ONE SYDNEY HARBOUR

BARANGAROO

R4A SUPPLEMENTARY DESIGN STATEMENT

June 2019

Aproved West Facade Skirt

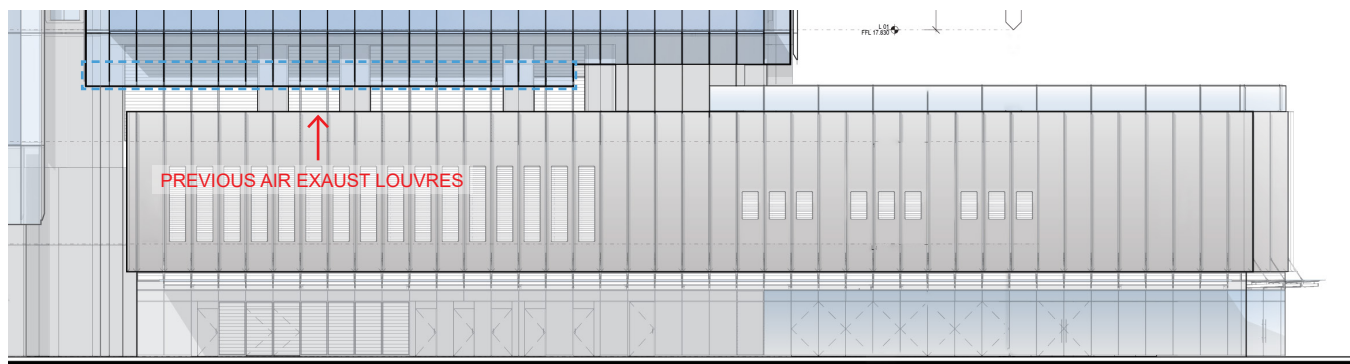
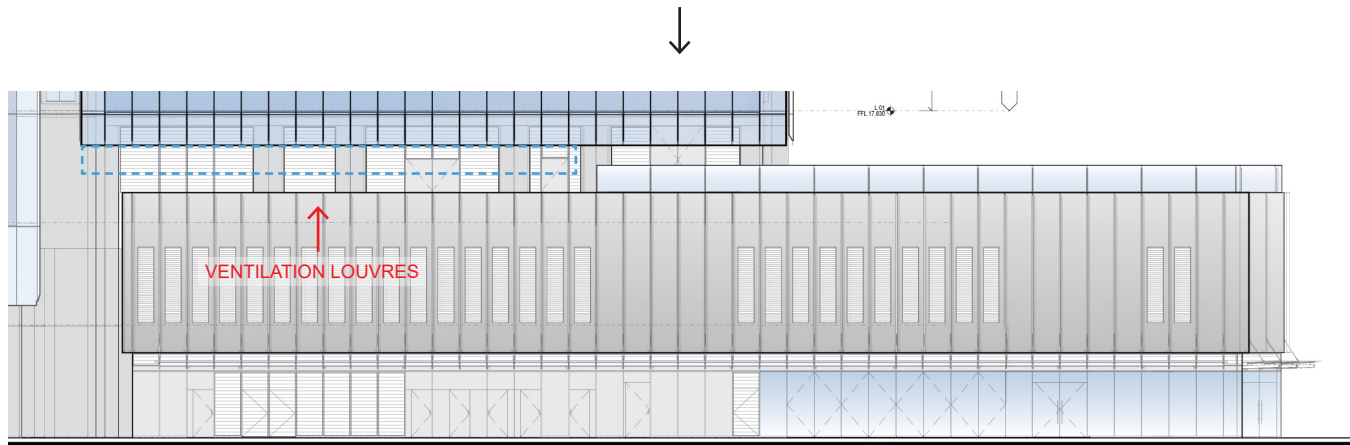
The skirt in the west façade of the building underwent an important fine-tuning. In the approved design, the northern skirt panels were different in height from its southern counterparts, creating a step in the bottom edge of this façade.

The step had to do with the previous ventilation strategy. In the approved scheme, Louvre panels at P2 were exhaust louvres (indicated with the red arrow), therefore, it should maintain a 6m distance from the apartments OCF above. That clearance was obtained by lowering the skirt. After relocation of mechanical services and revisions the louvres on P2 became regular ventilation louvres, eliminating the need to maintain such separation from the apartment’s openings.

Without this constrain came the opportunity to propose the realignment of those skirt panels matching not only its southern counterparts. The skirts are therefore simplified into 2 heights. A longer one, above the lobby, and a shorter, above the podium volume as shown respectively in orange and magenta in the following diagrams.

Proposed P02 North East Facade

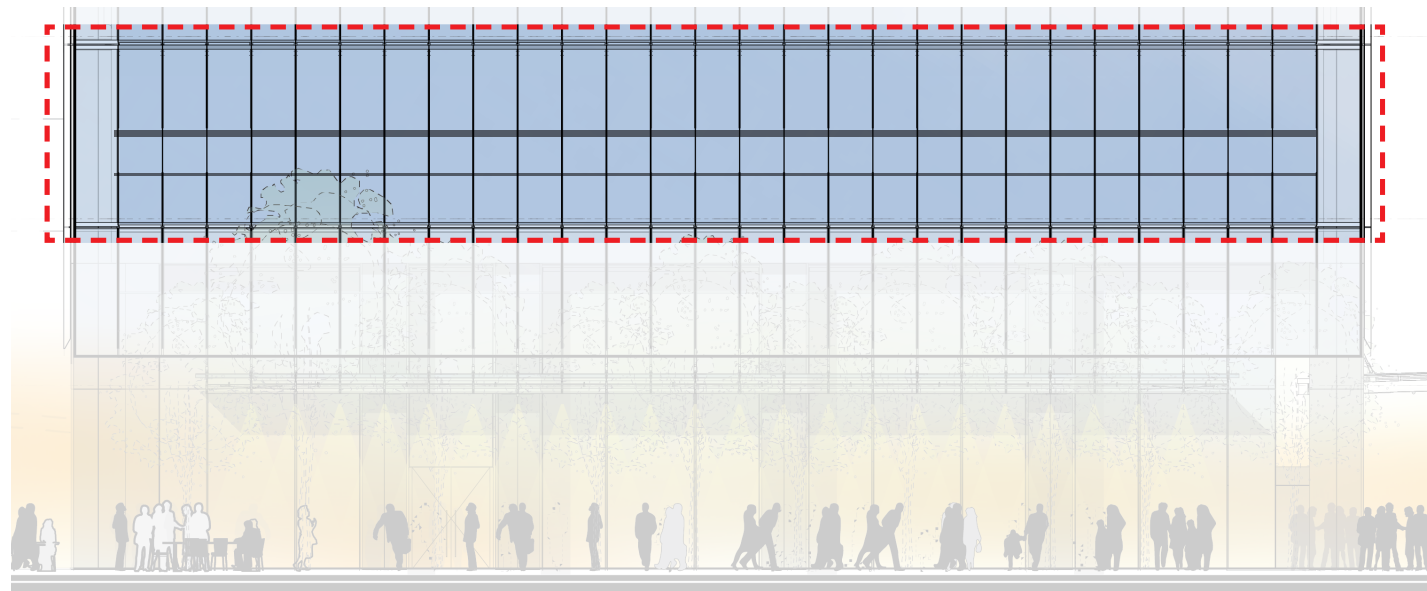
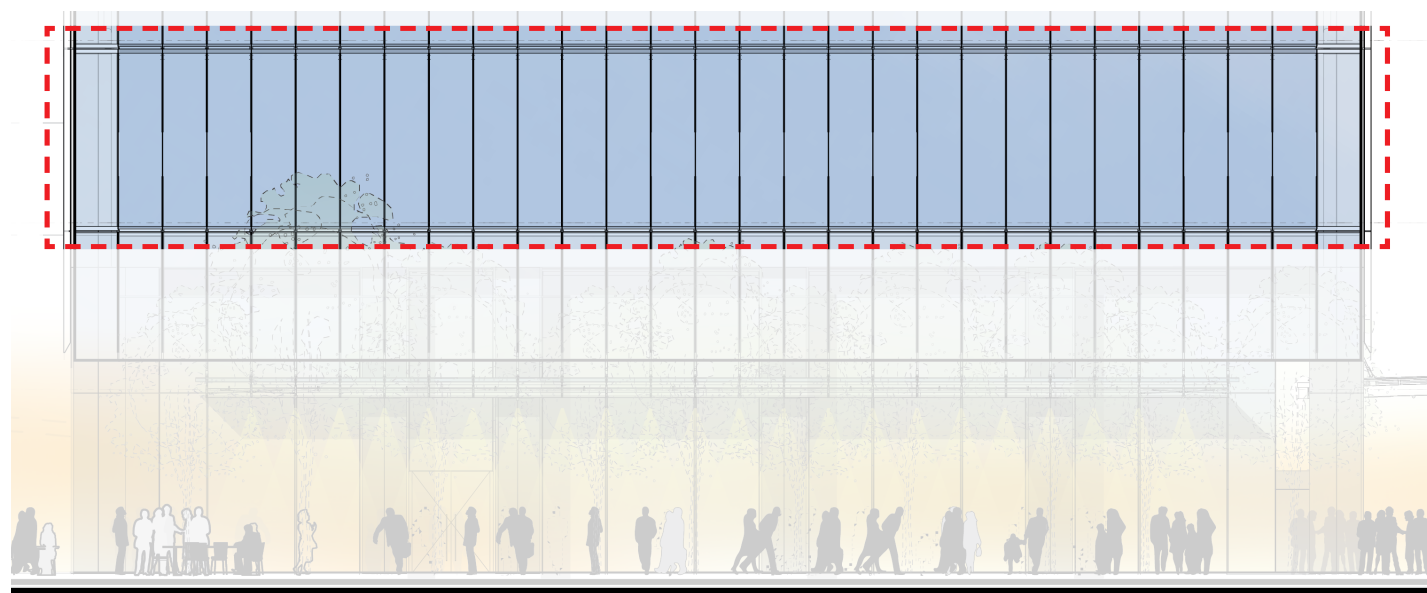
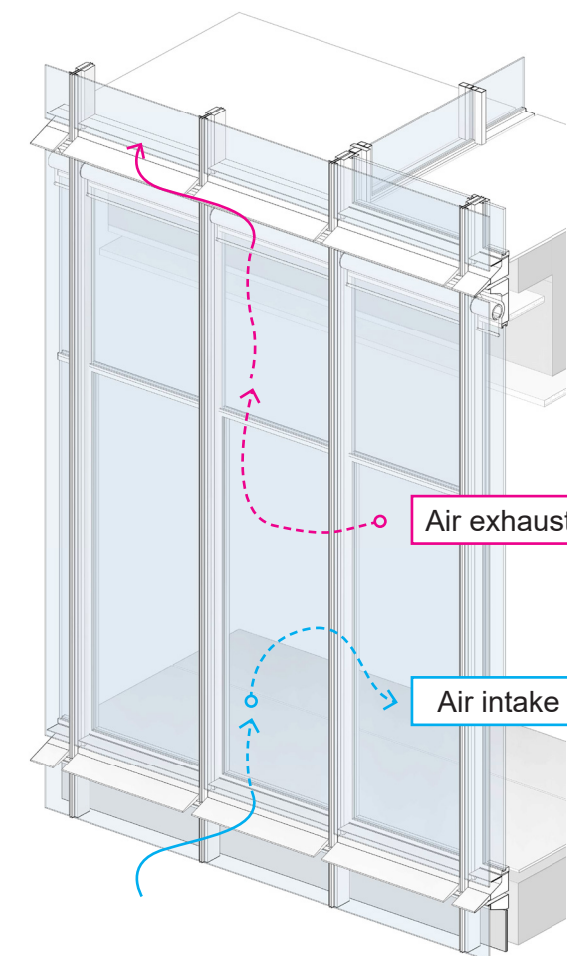
The lowermost facade level facing Hickson Park has been reconfigured from the approved design in order to provide a better user experience. Currently as approved, this space would have an external feel created by the usage of wintergarden sash window panels. Subsequent thermal studies have led to the realisation that the permanently opened gaps within the wintergarden facade system, and the airflow that these gaps allow, is likely to compromise the mechanical thermal control systems of this space leading to discomfort during days of high temperature.

As a response to these consequences, the wintergarden panels are proposed to be removed under this modification and replaced with Open Cavity Facade (OCF) modules instead. This is expected to create a more stable temperature for the users of the space and allow this room to better complement the external amenities area in R4B by offering residents greater choice between facilities throughout the year.

Importantly, this Open Cavity Facade (OCF) is still a fully operable facade that allows fresh air and breezes into this space during benign climatic conditions.

Diagrammatic schemes for "Mini OCF's" composition and operability

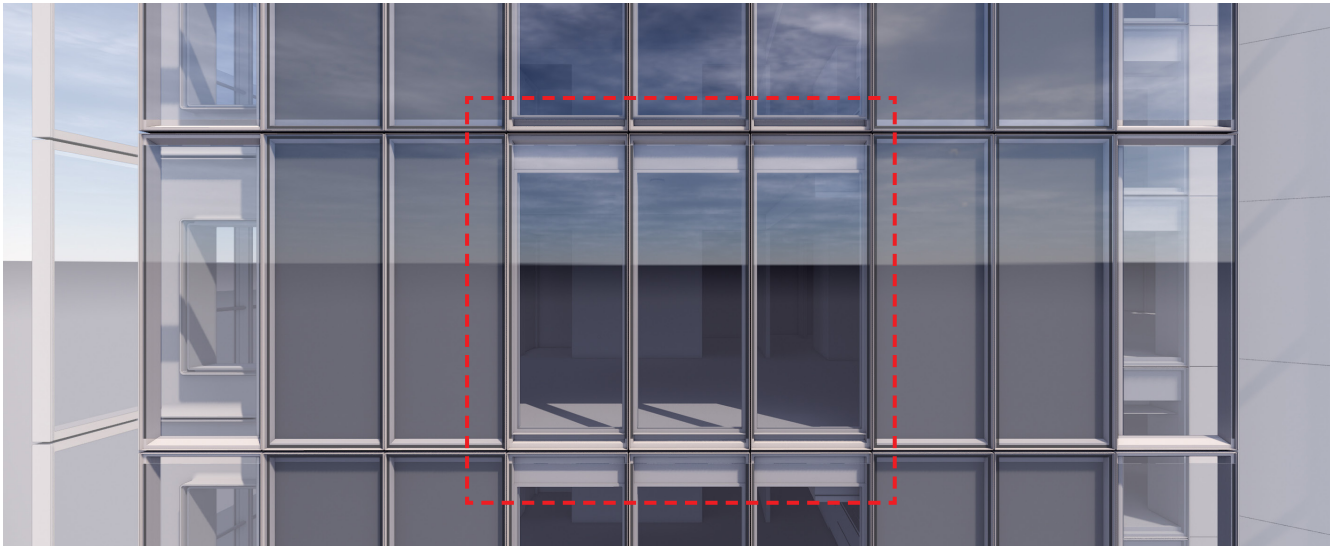
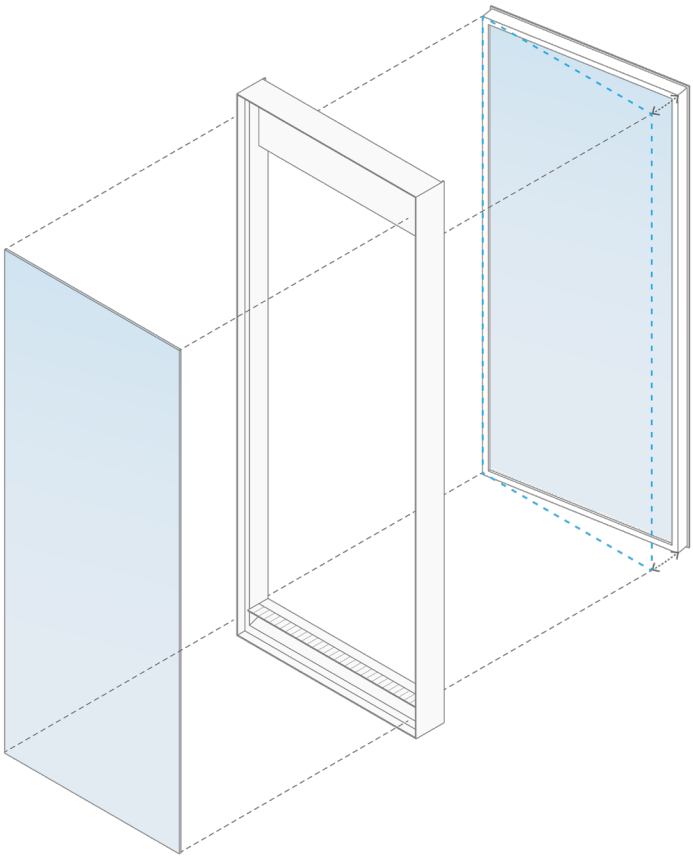
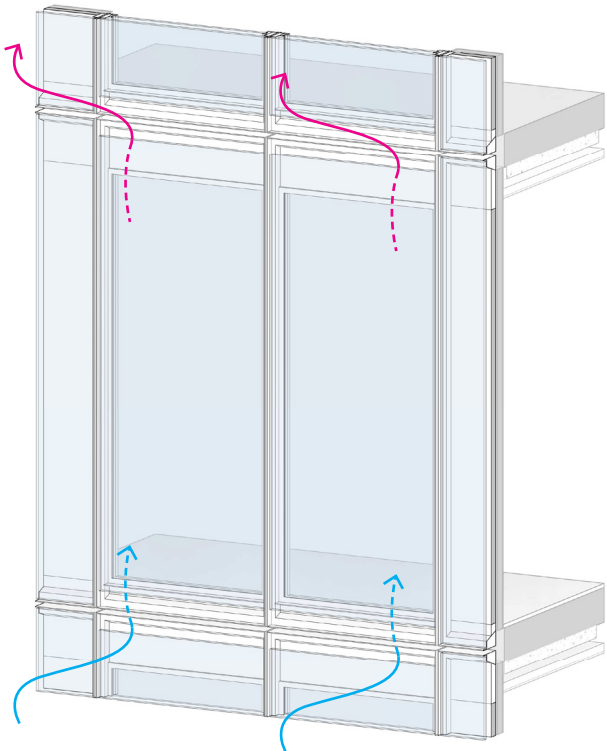
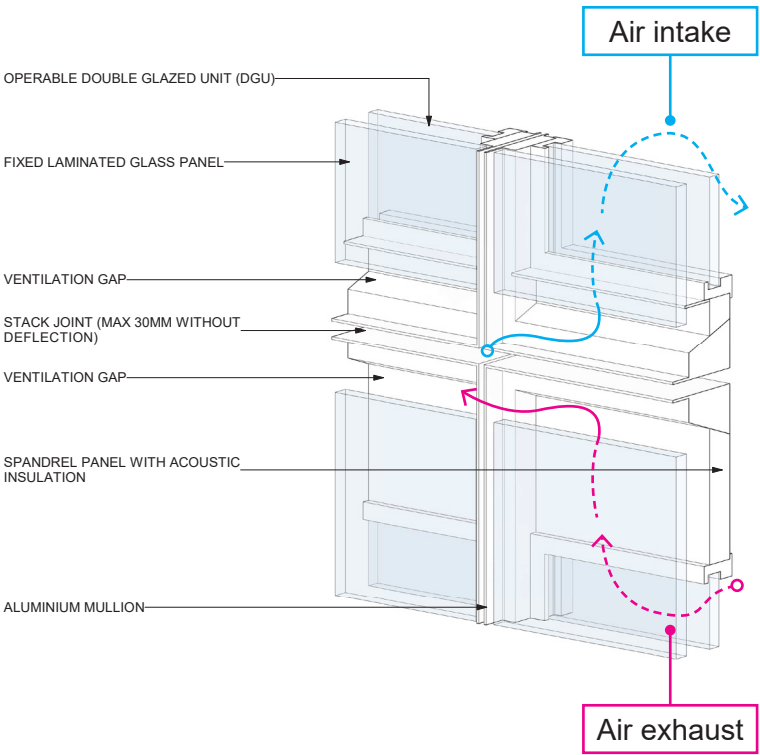
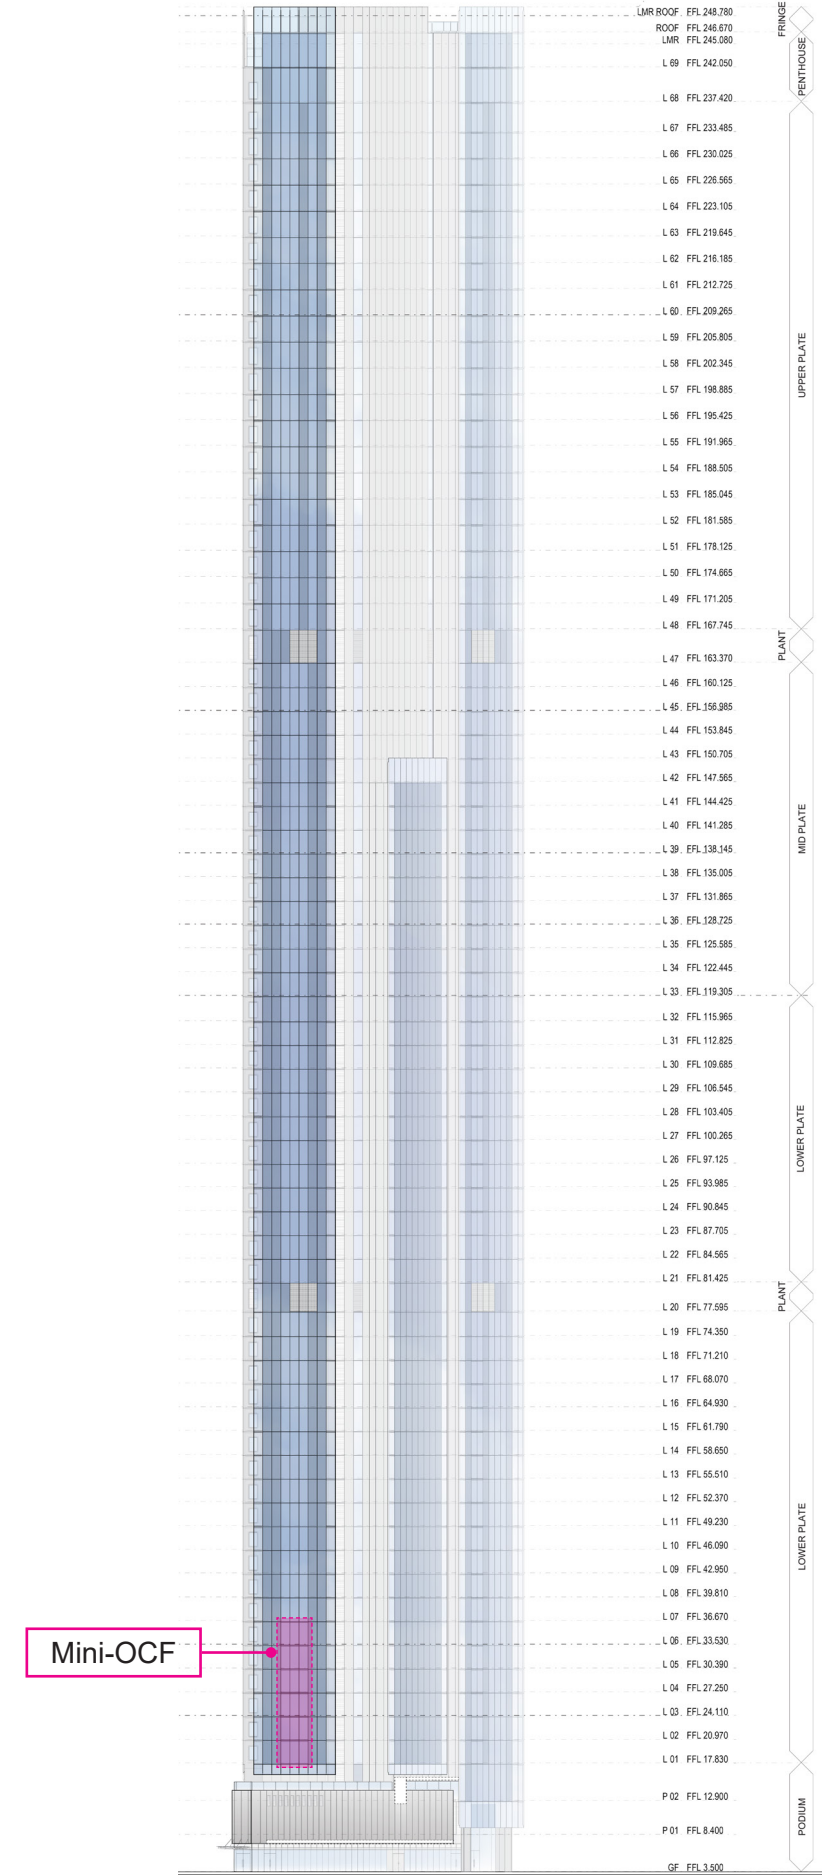
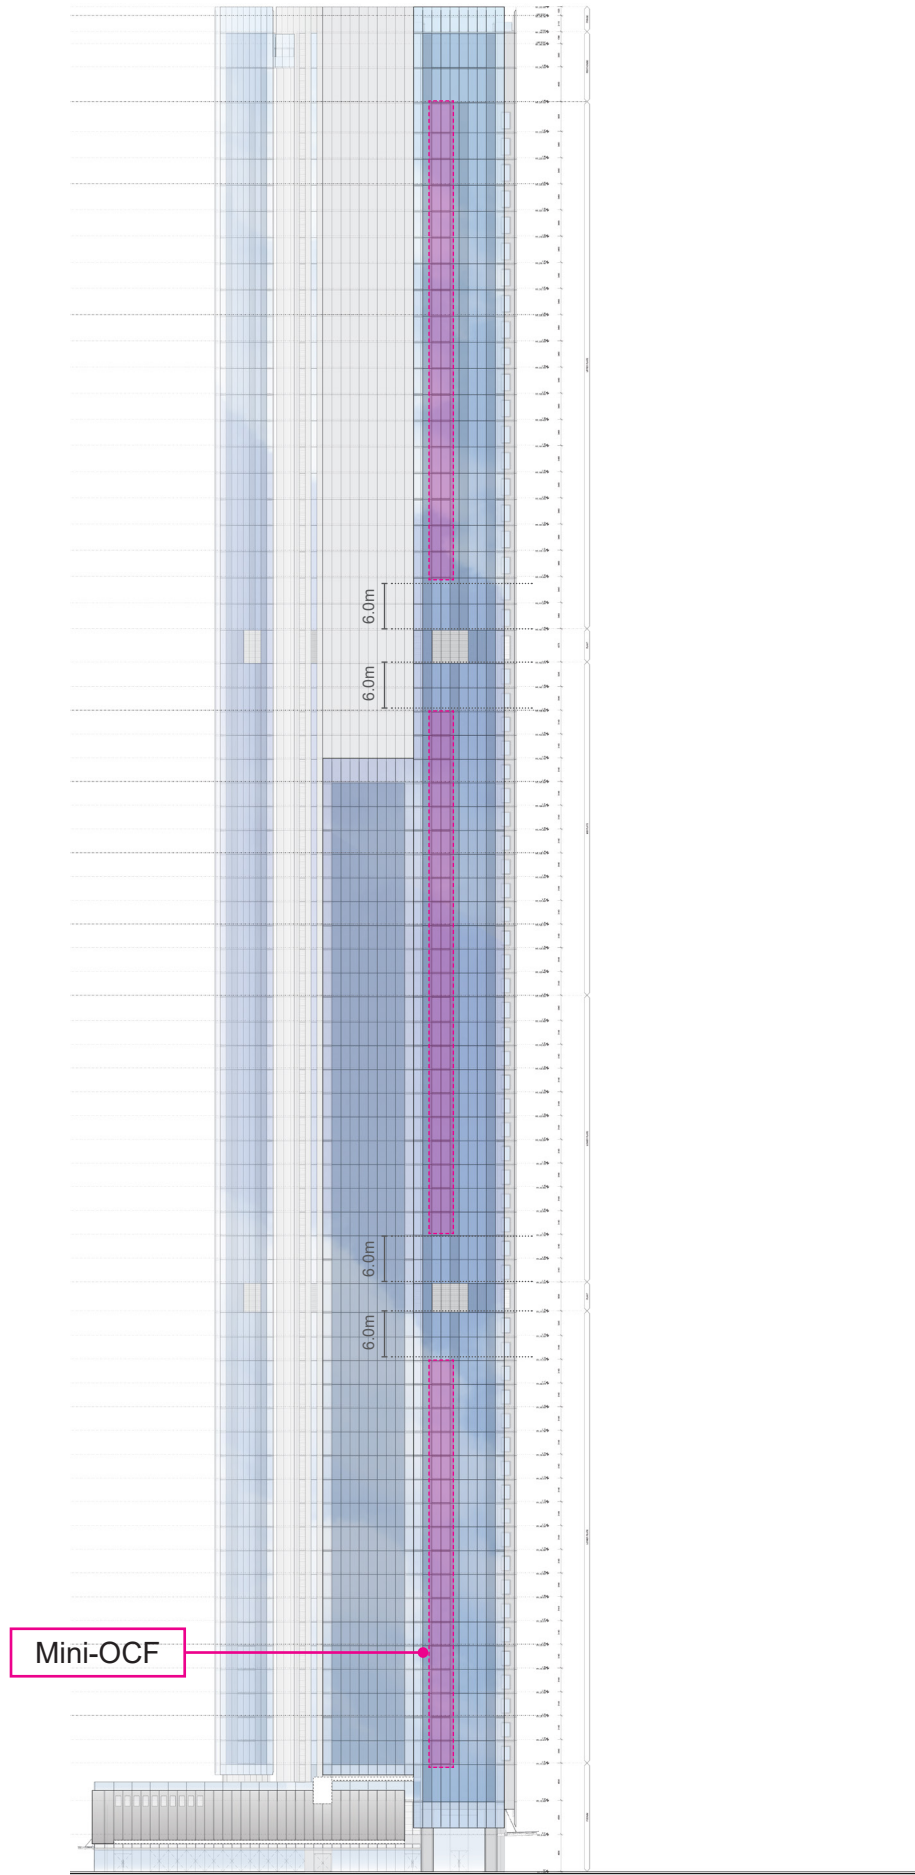
Currently, the South East facade facing bedroom (above level 7) is a fixed double glazed unit which means that a mechanical ventilation solution is required.

In order to increase the amenity of these bedrooms, a new facade typology has been introduced via this modification which provides natural ventilation to all levels aside from those within 6 metres of the two plant room levels. The introduction of this system also enhances the degree to which these apartments are cross-ventilated.

In the South facing apartment, wind reports demonstrated the need for a second opening in order to properly cross-ventilate that apartment in lower levels. For compliance with the Apartment Design Guide Objective 4B-3, The mini - OCF facade type has been introduced on the south elevation to provide cross ventilation to the south east apartment up to level 6. Above this level, with higher wind pressure differences, the apartments are expected to be well ventilated with the openings provided for in the west facing primary façade.

This facade typology is related in concept with the primary Open Cavity Facade (OCF) system but is reduced in depth from 250mm to 185mm as there is no requirement for an external fabric blind as there is with the primary facade typology. For this reason, this system is referred to as the 'mini-OCF system'.

In every other respect, including glass type and means of operation, the mini-OCF system is identical with the primary OCF system.
